Planning & Development Consultants

RESPONSE TO THE SUBMISSION OF SIGNIFICANT FURTHER INFORMATION AS PART OF AN EXISTING THIRD PARTY PLANNING OBJECTION IN RESPECT OF A PLANNING APPLICATION IN THE AREA OF DUBLIN CITY COUNCIL, REG. REF. 2683/21. THE DEVELOPMENT CONSISTS OF THE CO PERMISSION FOR DEVELOPMENT AT A SITE (C.039HA) AT GLENAVON HOUSE, 46 BALLYMUN ROAD, GLASNEVIN, DUBLIN 9. THE SUBJECT SITE IS GENERALLY BOUNDED TO THE WEST BY BALLYMUN ROAD AND CLONMORE COURT APARTMENTS, TO THE NORTH BY GLENAVON COURT AND HILLCREST COURT APARTMENTS, TO THE EAST BY THE REAR GARDENS OF HOUSES ON ST. MOBHI ROAD, AND TO THE SOUTH BY MOBHI COURT APARTMENTS AND HOUSES AT THE HAVEN. THE DEVELOPMENT WILL CONSIST OF THE CONSTRUCTION OF A 5 TO 6 STOREY APARTMENT BUILDING (TOTAL GFA C.5,330 SQM EXCLUDING CAR PARK), PARTIALLY OVER BASEMENT, ACCOMMODATING 52 NO. RESIDENTIAL UNITS (13 NO. 1-BED APARTMENTS, 9 NO. 2-BED APARTMENTS, 17 NO. 2-BED DUPLEX APARTMENTS, 8 NO. 3-BED APARTMENTS AND 5 NO. 3-BED DUPLEX APARTMENTS), ALL WITH PRIVATE BALCONIES ON THE EAST OR WEST ELEVATION (ETC). 1 NO. CAR SHARE SPACE AT SURFACE LEVEL. 37 NO. CAR PARKING SPACES AT BASEMENT. 80 NO. BICYCLE PARKING SPACES. ESB SUBSTATION A

Fig. 24: Existing and proposed trees (from Landscape Masterplan)

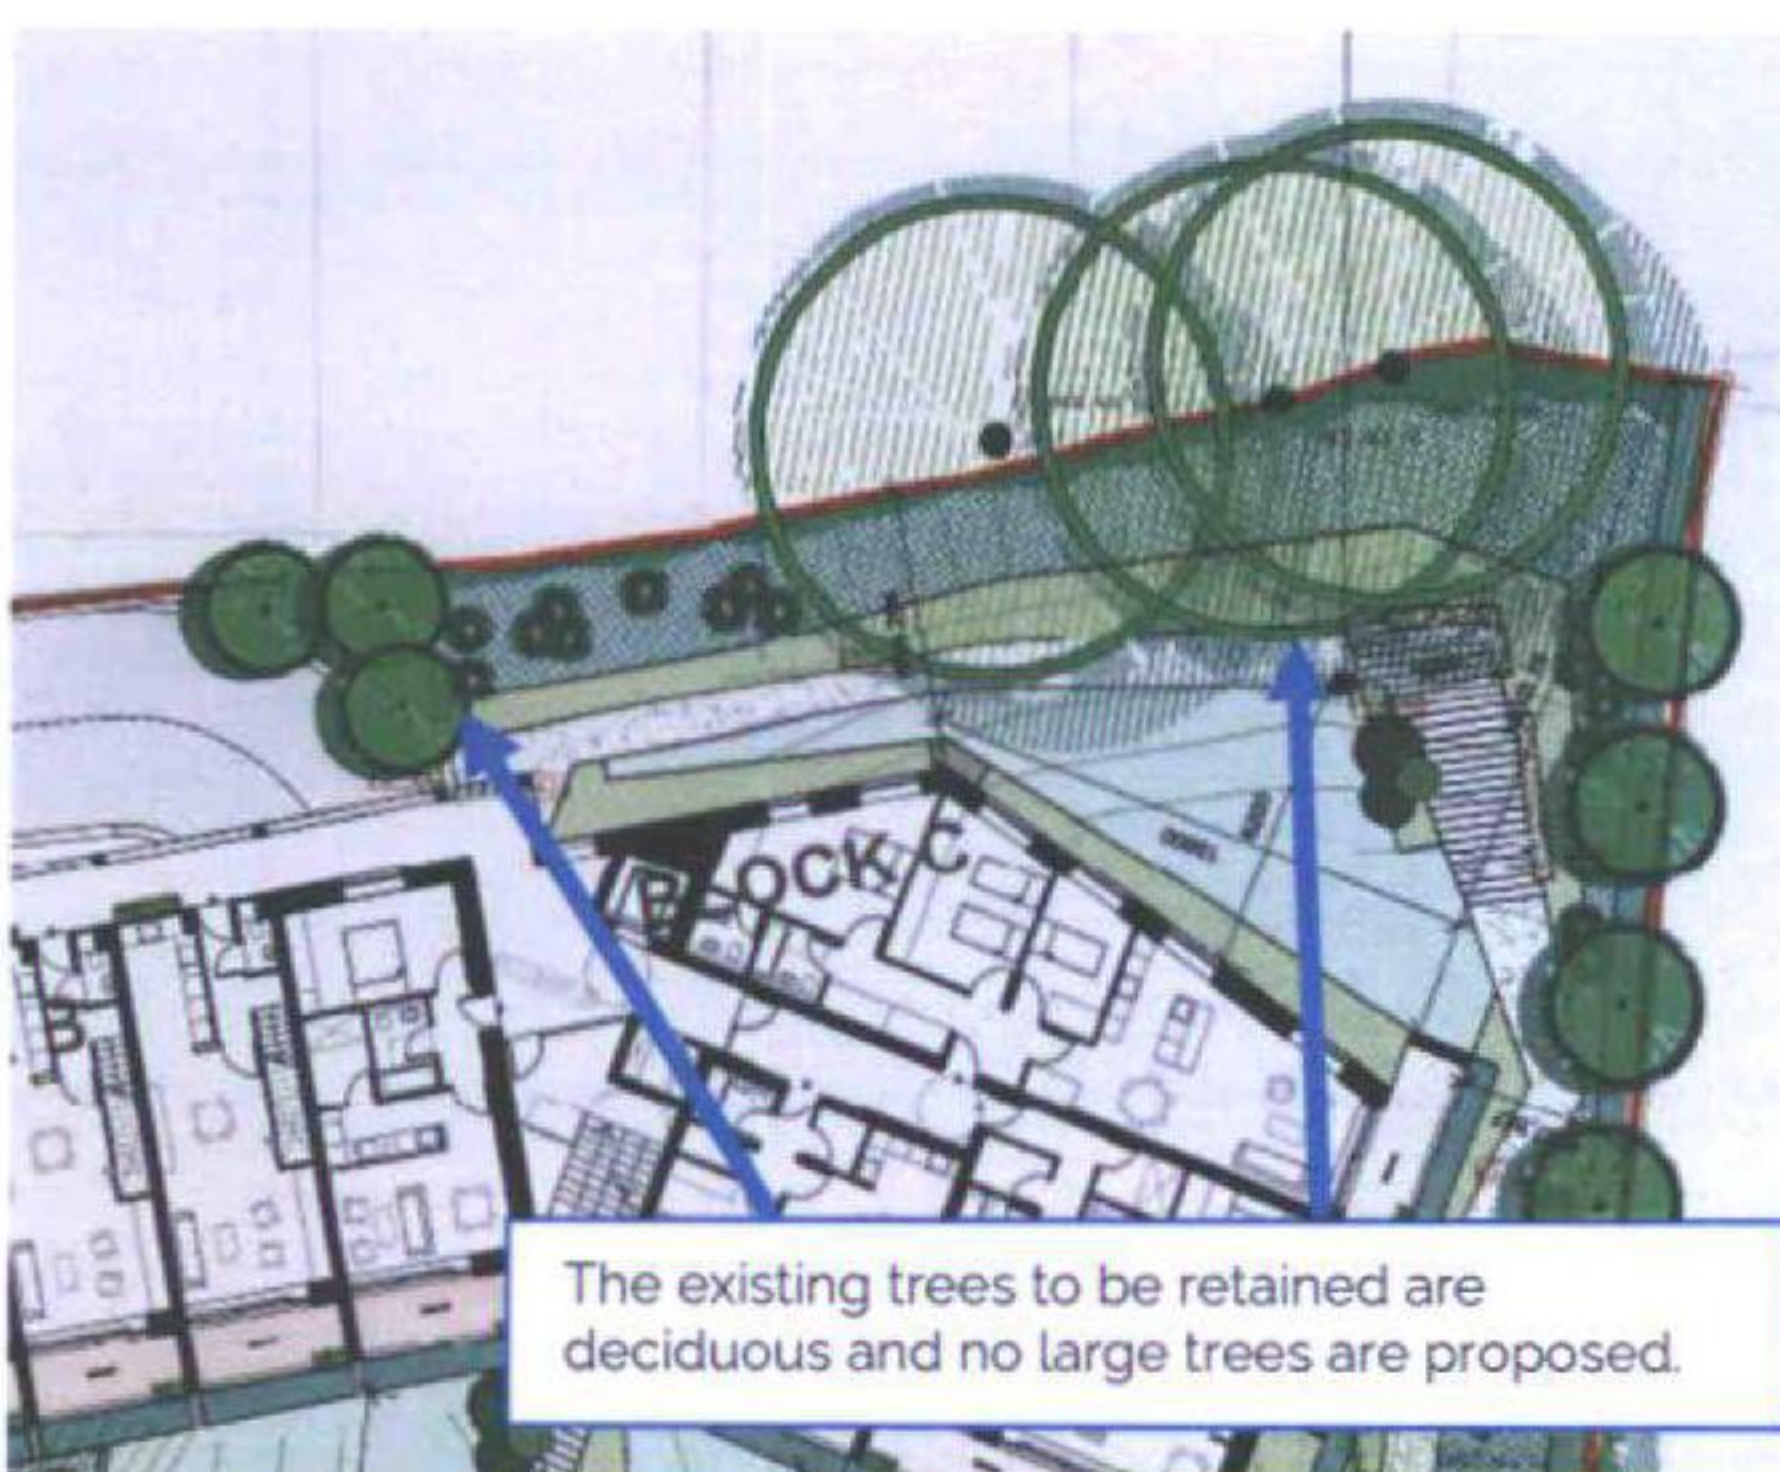
The massive Tree No. 50 at the scheme entrance is proposed to be removed as this could not survive the construction phase. BPS reviewed the Applicant's landscape tree planting proposals, and these do not mitigate the extreme levels of tree losses proposed.

The only way to mitigate tree losses is to reduce tree losses. This means retaining Glenavon House and reducing the scale of blocks B and C. The east side and north end of the site need to be treated far more sensitively than is currently proposed. The submitted landscape plans does not offer anything which could preplace what is currently a mature sylvan environment.

Fig. 26: The scale of the SFI basement car park and services area – very large for a 42 unit scheme

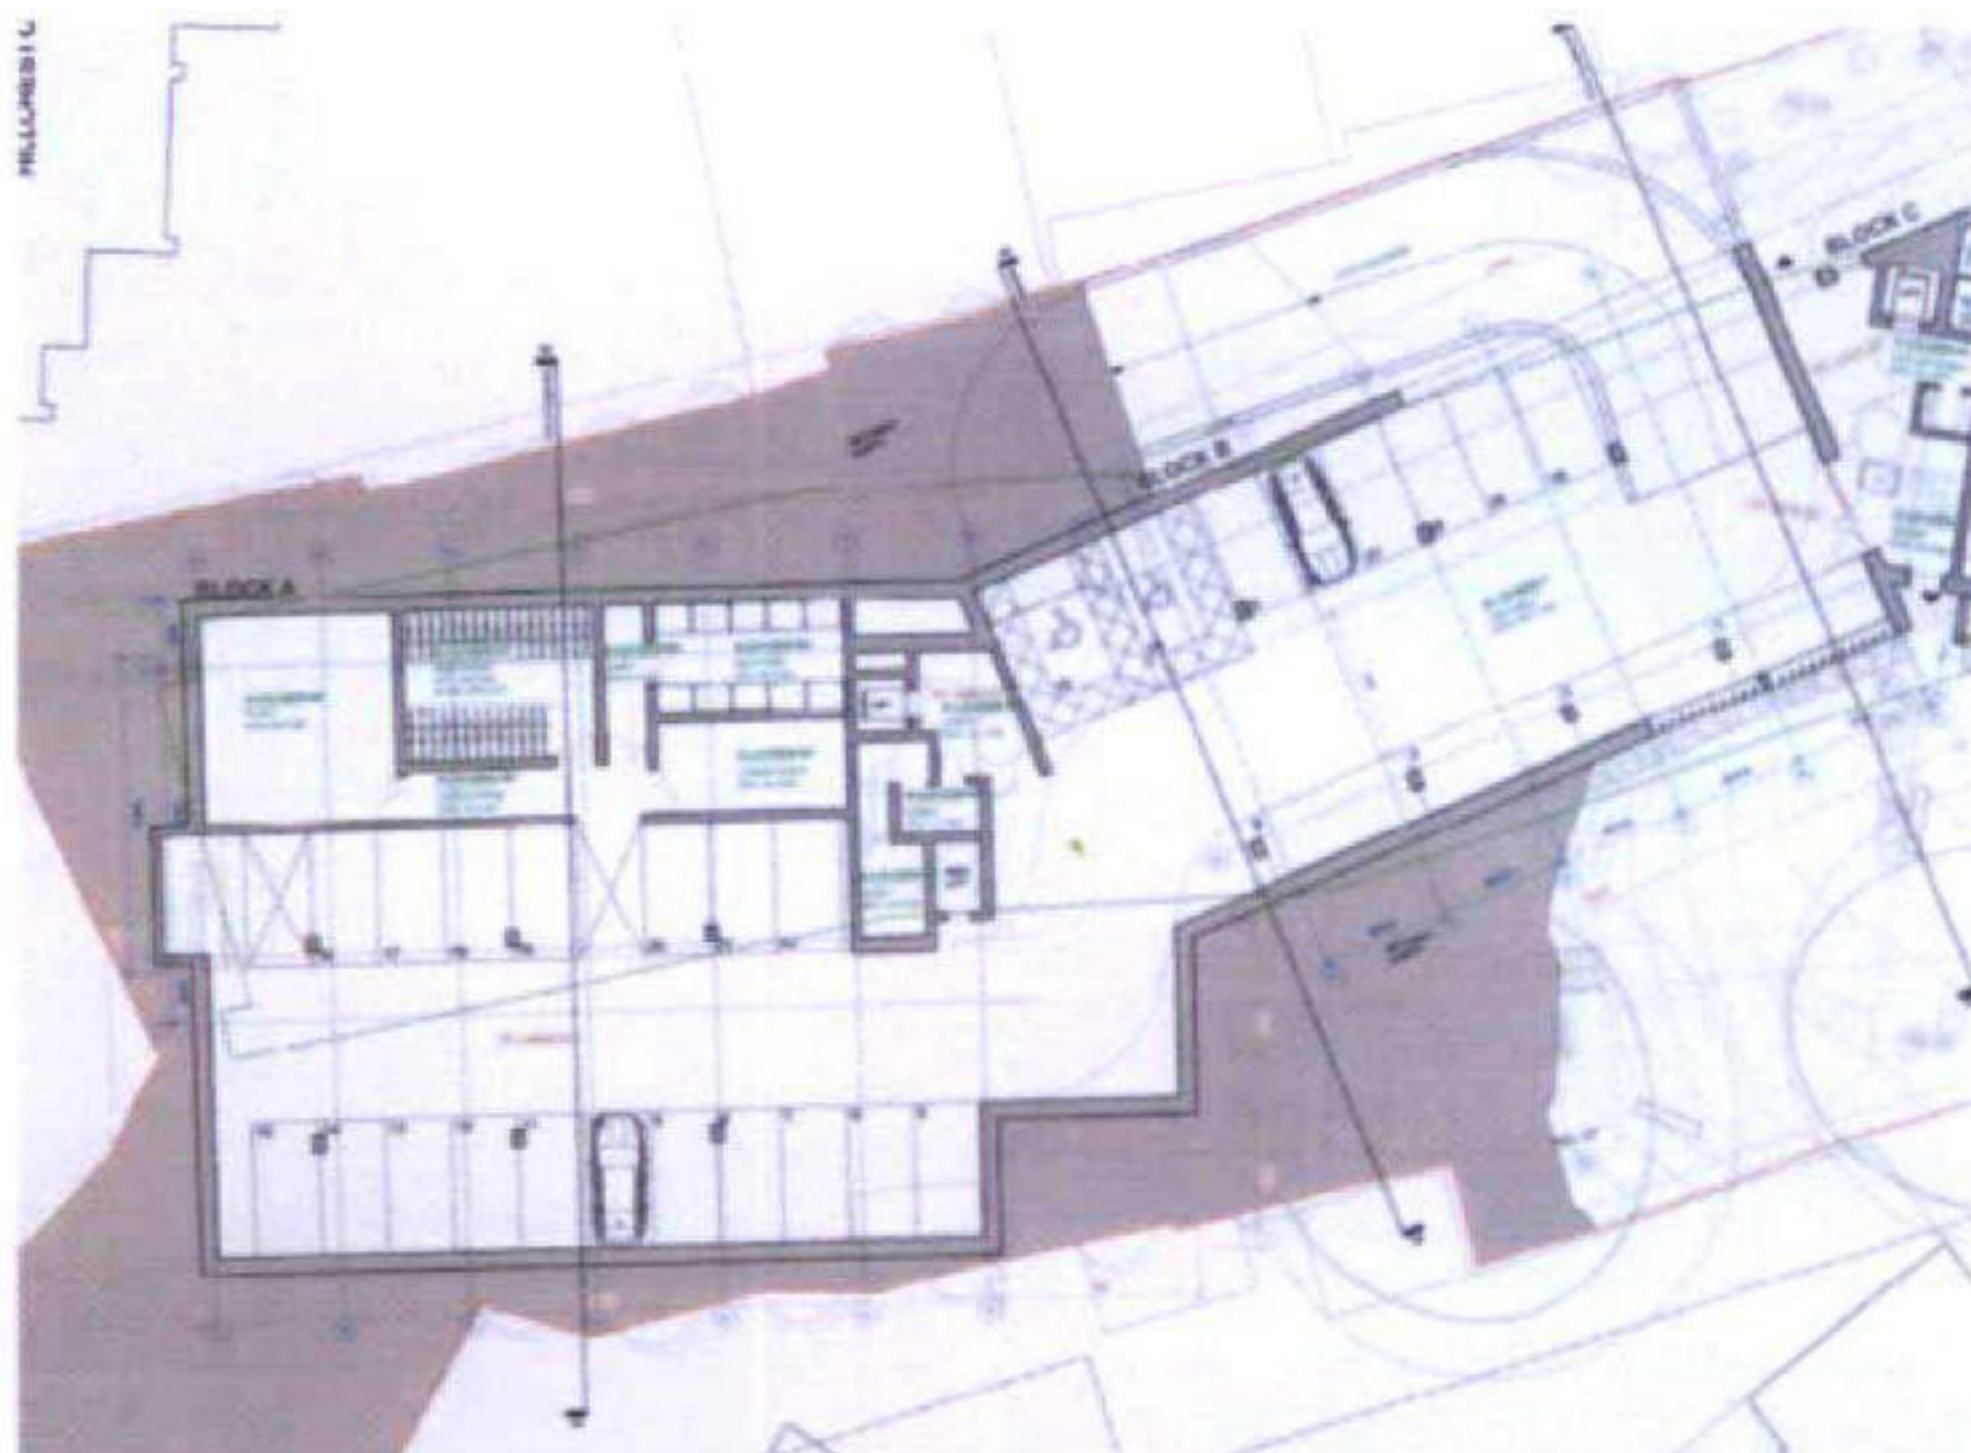
While the Applicant has reduced the number of units in the scheme, the basement car park remains very large for such a small site. It contains no less than 30 car parking spaces, 4 no. motorbike spaces, bike storage area for 50 bikes (more than 1 per unit). Reference is made to how "sufficient space for a centralised heating plan solution" is included to the basement which may or may not happen – this has also inflated the size of the basement.

Concerns arise that the car park is now significantly over-scaled for this scheme and this unnecessary scale would impact negatively on our clients' properties as set out in their original Planning Objection Report. The basement should be significantly reduced in scale and re-sited.

Fig. 32: The existing boundary treatments are not brand new – those in the CGIs look new

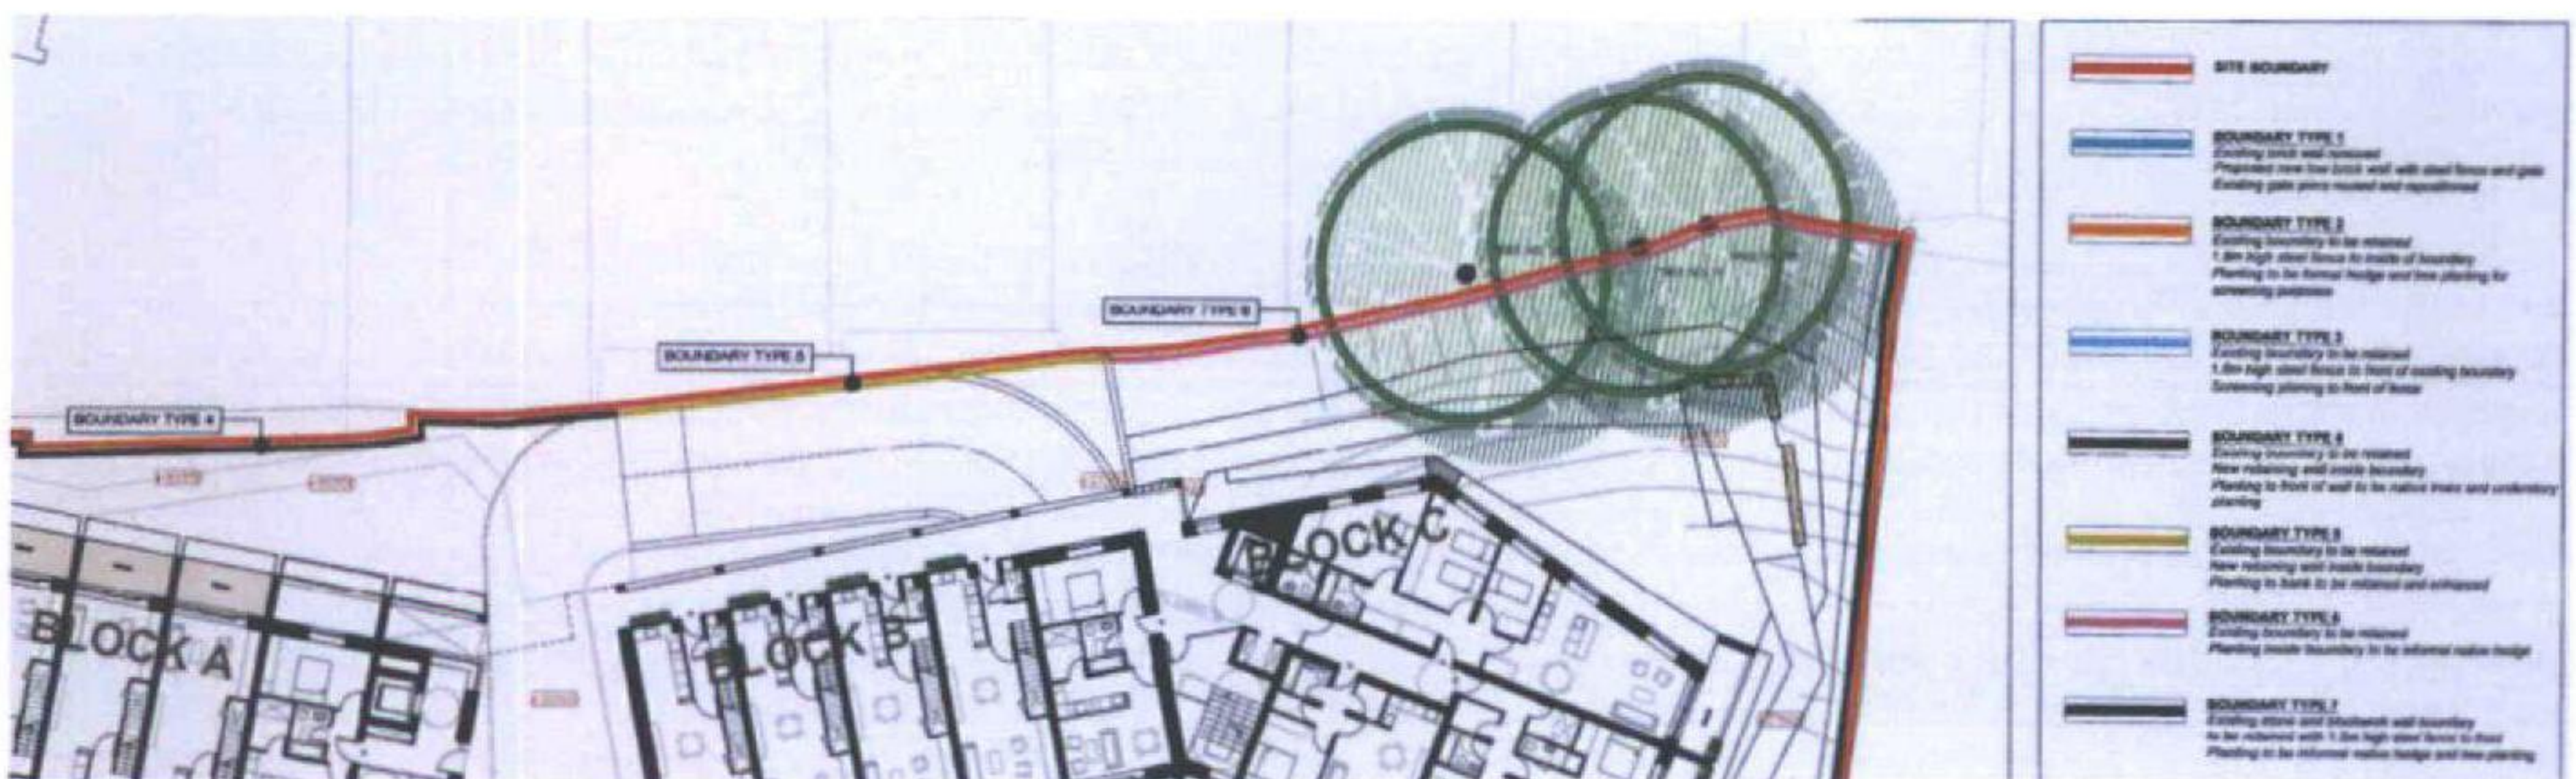
Our clients note how the Applicant claims not to need to alter the existing boundary treatment to their properties yet all the submitted CGI images show what appear to be shiny new boundary treatments to their properties. The answer to this conundrum is that the Applicant refers to how "new boundary treatments are installed inside of the red line boundary to the applicants side".

Our clients are not reassured in this regard. They are confused by the proposals which seem aimed at speed of installation and to avoid reaching any agreement with our clients over the existing shared boundary. The Applicant has not addressed concerns set out in their original Planning Objection Report which are 'taken as read'. No reference is made to indemnifying our clients over possible damage to their rear gardens from subsidence.

Fig. 37: The car park entrance and access road sited hard up to the shared boundary

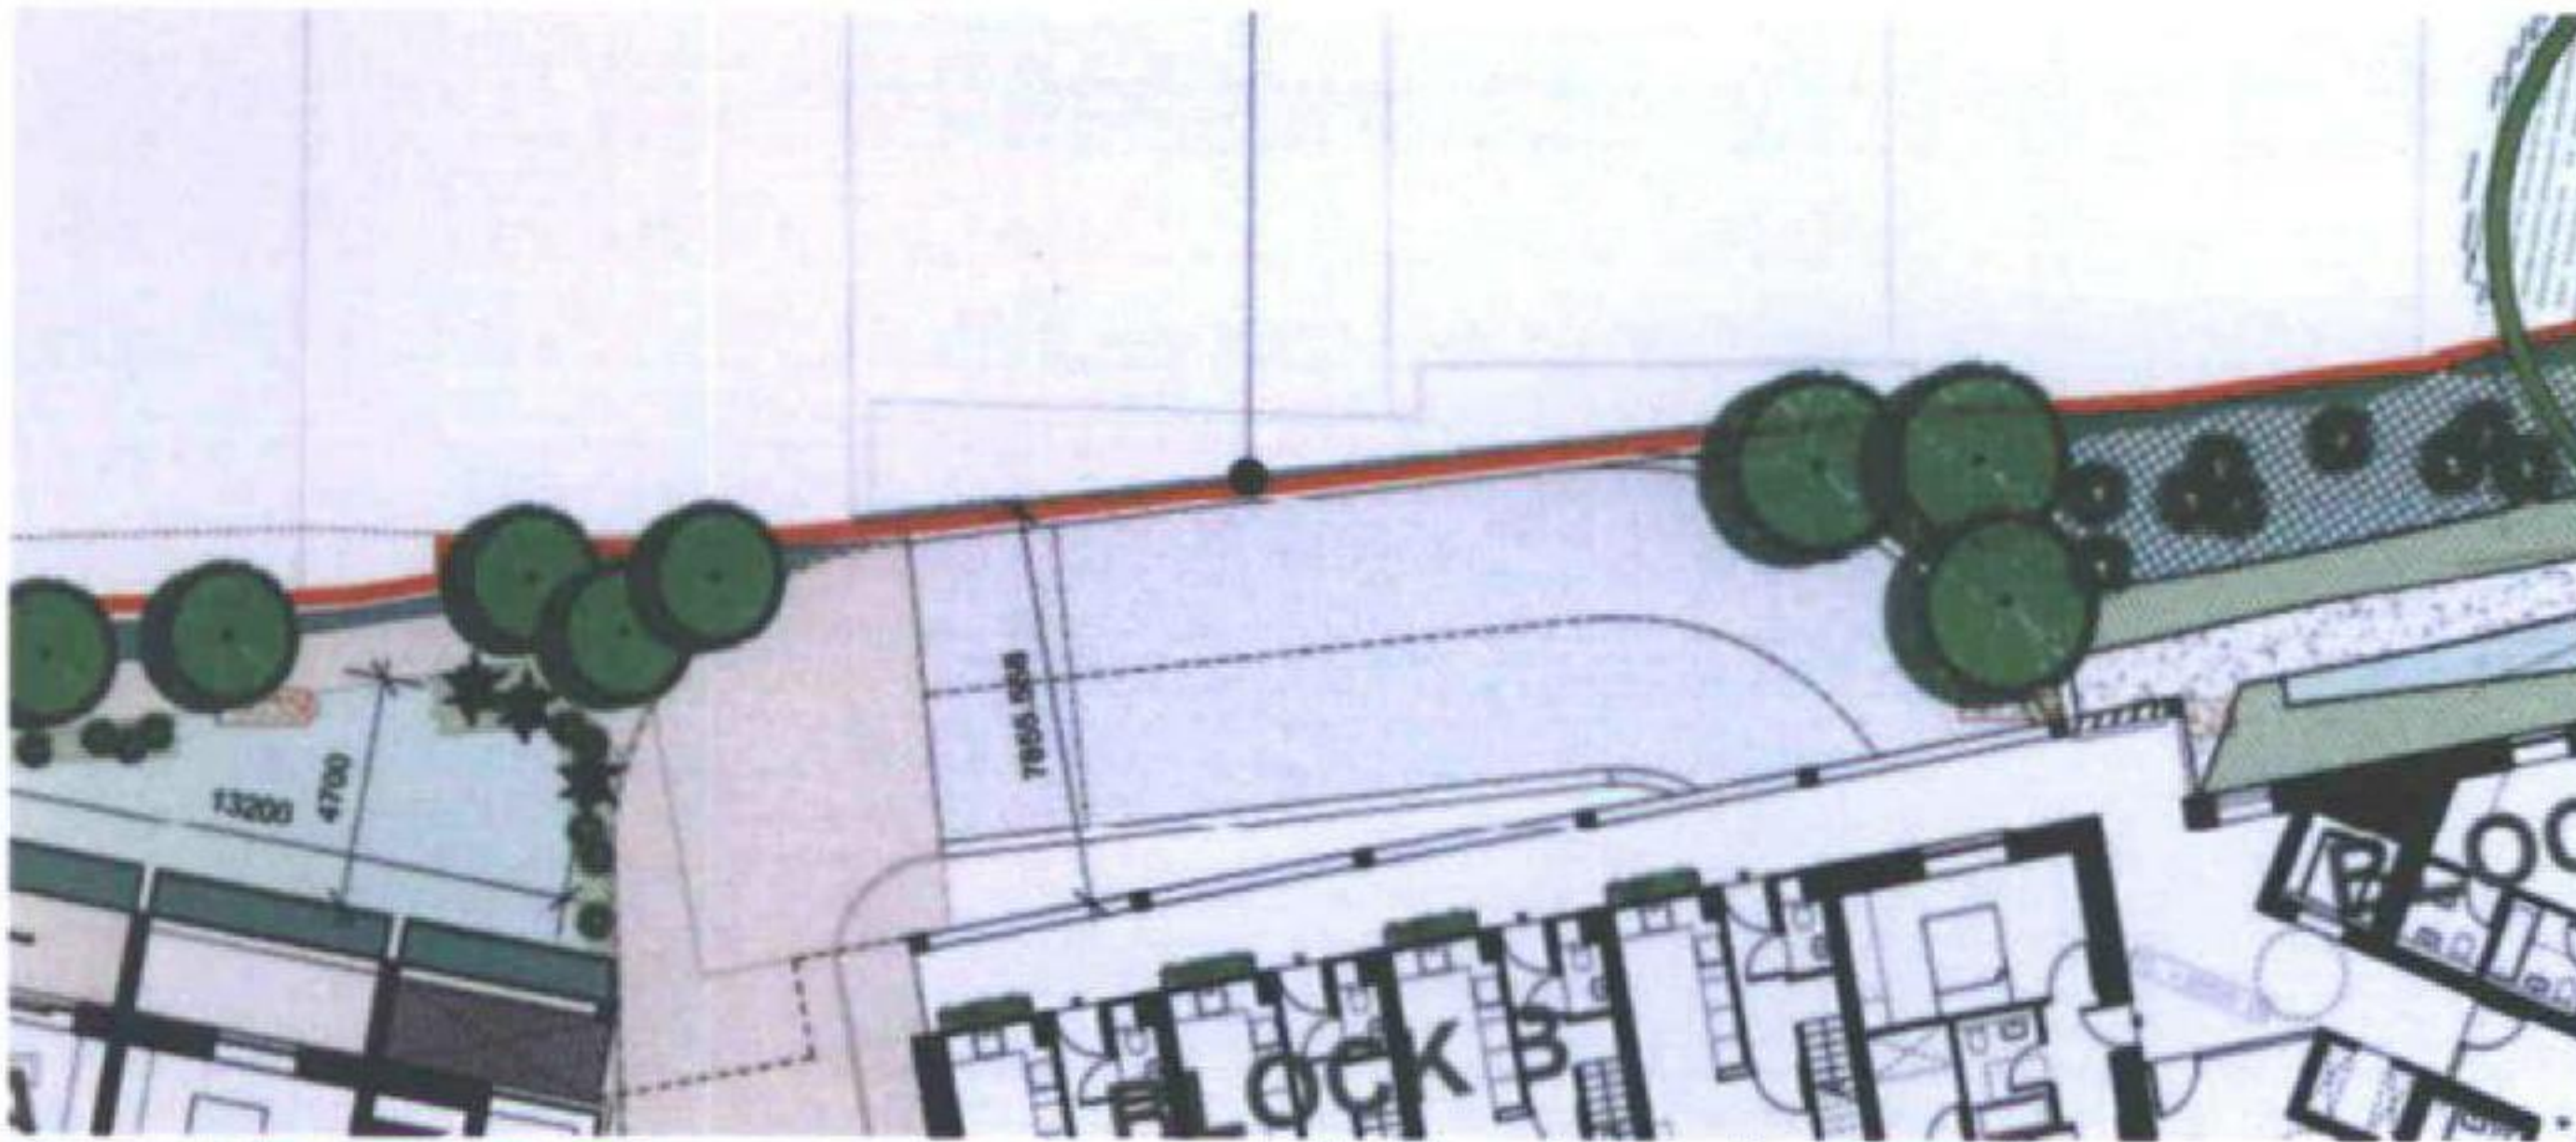
The access route to and siting of the car park entrance remains hard to understand and/or to justify. This entrance is immediately alongside our clients' properties and both the internal access road, and the entrance detract from the open space provision and quality of the external areas within the scheme. They also reduce opportunities for planting of trees and shrubs.
